Re: Planning application ref. 2013/8158/P: 27-29 Whitfield Street, W1:

- (1). Applicant's drwg. no. A-01.3-103 rev. D: (Proposed) Colville Place Elevation,
marked up by CSA.
- (2). Applicant's drwg. no. A-01.3-102 rev. D: (Proposed) Courtyard Elevation,
marked up by CSA.
- (3). Applicant's drwg. no. A-01.1-103 rev. F: (Proposed) New Plans: 3rd Floor & Roof Plan,
marked up by CSA.

APPENDIX 1'S DEMOLITION
MARKED-UP BY CHARLOTTE STREET ASSOCIATION:
9/12/2014 Scale 1:100 of A3 size.

27-29 WHITEFIELD STREET, LONDON
SE11 4JH
020 7463 1000
A-01-3-103 D

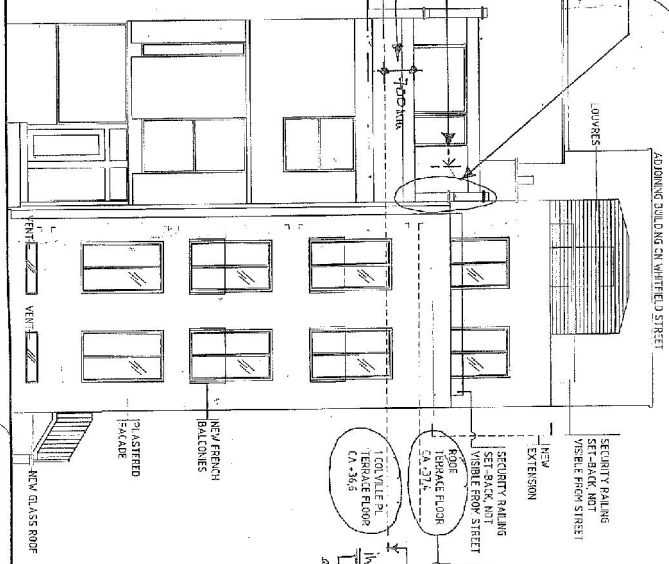
Part 1 wall shown incorrectly:

Party wall is shown in wrong location. It should be further over (towards 22.5m) so that it sits up with vertical plane below.

- Right hand side of drawing is much further over, nearer party wall.

Exist. balustrade at Caville Place:

- unusually drawn as 100mm height
- existing height = 100mm

Incorrect level of Caville Place terrace

Dalotie drawing shows this proposed terrace at 38.15m level (i.e. at 750mm higher level) Proposed bump No. A-01.2 - 101 Row C shows two intervals floor level as +37.4. Thus, clearly that proposed terrace is at same level, after taking account of thickness for insulation & finish/fill etc. for terrace - would expect higher level than the 37.4.

How does this proposed terrace level at 37.4 relate to the existing roof at Whitefield Street which exist. level is shown as:

37.85 on the Dalotie drawing (i.e. 450mm higher) or 37.34 on architect's drawing (i.e. 340mm higher)

Incorrect level for exist. terrace at 1 Caville Place

existing terrace level is much lower (by at least 400mm)
